# CITY OF ALBUQUERQUE

RE: **Big I Commerce Center - Drainage Management Plan**  
SW Corner of Candelaria & University; PE Stamp: 12/12/12 File # **H15-D065**

Based upon the information provided in your submittal received 12/13/2012, the above referenced Drainage Management Plan (DMP) can not be approved for Development Review Board (DRB) Platting action until the following comments have been addressed:

H15 - D039  
Contours (1985)

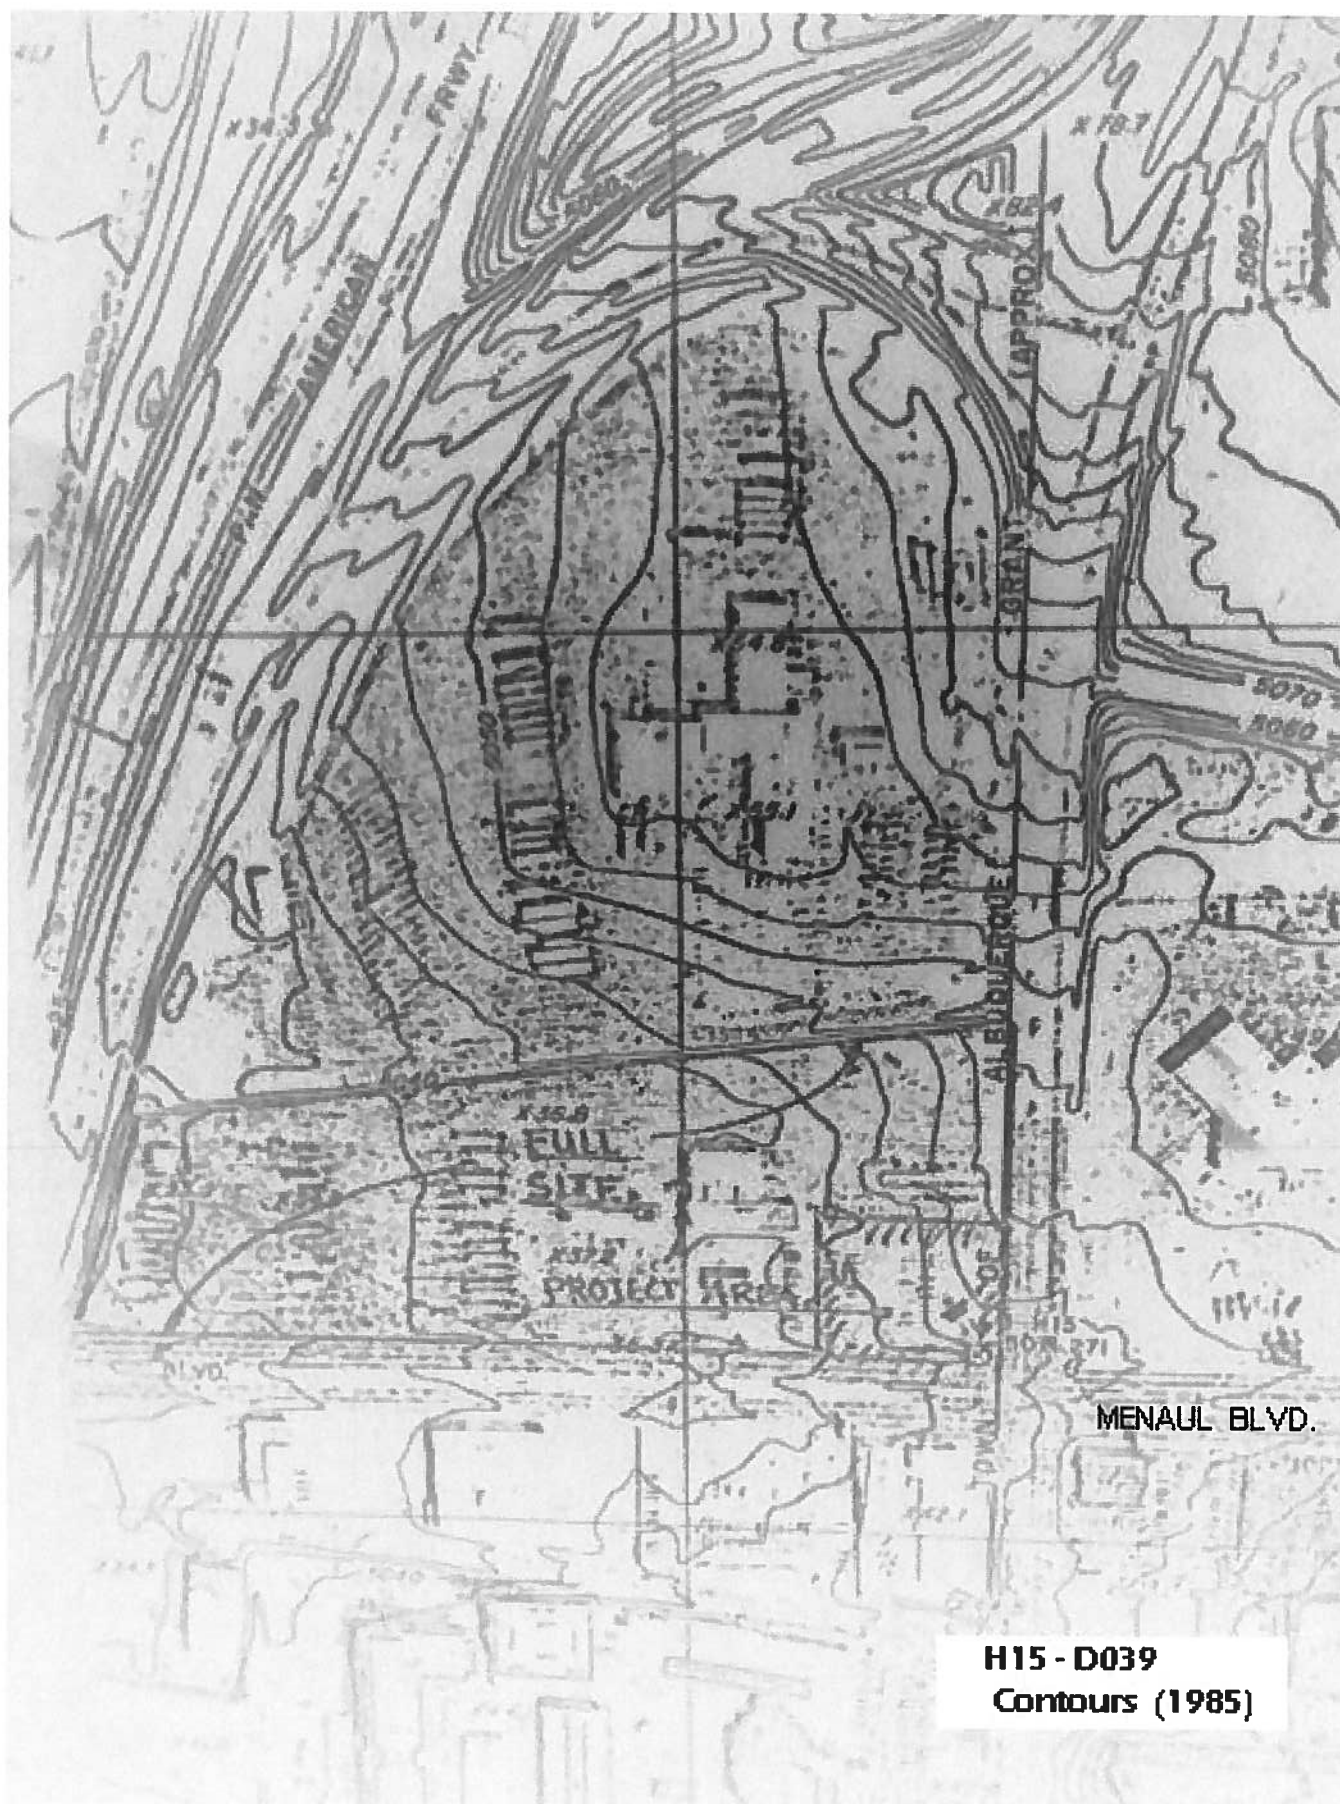
5. My review of 1985 drainage records revealed contours that most of the run-off from this site, toward the truck stop, was intercepted by a swale that routed flows west and south, around the north boundary of the truck stop paving. A 1985 contour map is attached for reference (Exhibit A). Recent aerials and contours of the site suggest that post-Big I grading and erosion on this site has filled in a portion of that swale, inappropriately increasing runoff to the truck stop paving.

- a. The Pre-development conditions layout must subdivide Basin B-2 such that the westerly portion includes about 0.4 acres which, historically, should be diverted around the truck stop paving.

- b. The Conceptual Drainage plan must restore the earlier diversion of flows, and limit the developed flows to the truck stop paving to the historic rates from the easterly portion of Basin B-2.
